TO: Mercedes-Benz Dealer Principals, General Managers, Sales Managers, Service Managers, Parts Managers	FROM: Gregory Gunther, Department Manager, Vehicle Compliance and Analysis, Engineering Services
RE: Service Campaign with RETAIL HOLD 2019040031 Launch Notification Check Tire Marking, Replace if Necessary MY19 238 (E-Class Coupe, Cabriolet)	DATE: May 3rd, 2019

Campaign No. 2019040031, May 2019

SUBJECT: **Model E-Class Coupe (238 platform)**
Model Year 2019

Check tires and replace if necessary

**Figure 1**

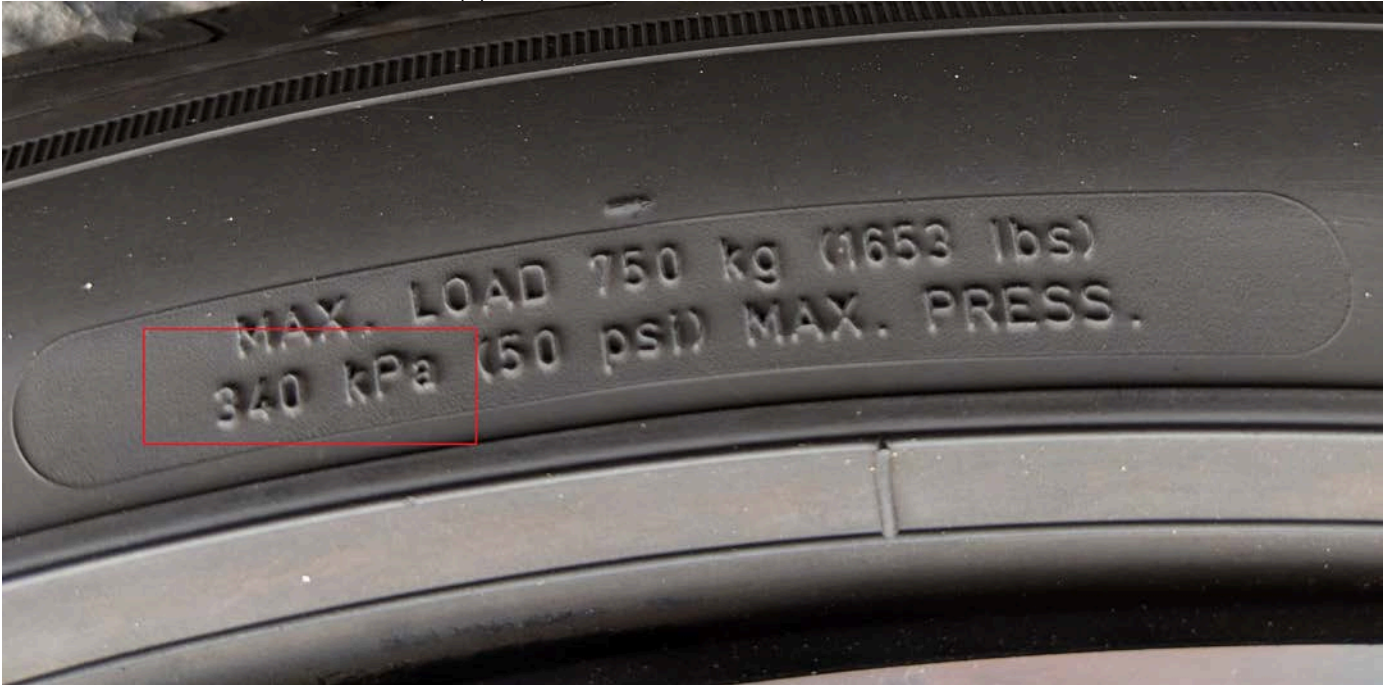
1. Confirm tires of the manufacturer **Pirelli** model **Cinturato P7** with the dimension **245 /45 R18 100Y XL MOE** are installed on the vehicle.
2. Check tire sidewall marking for max tire pressure(**figure 1**). If 340 KPa is indicated Perform work procedure(a). If 350 KPa is indicated end measure(b).

- a. Tires installed with 340 KPa: Perform **work procedure**.
- b. Tires **not** installed or **350 KPa**: **End measure**.
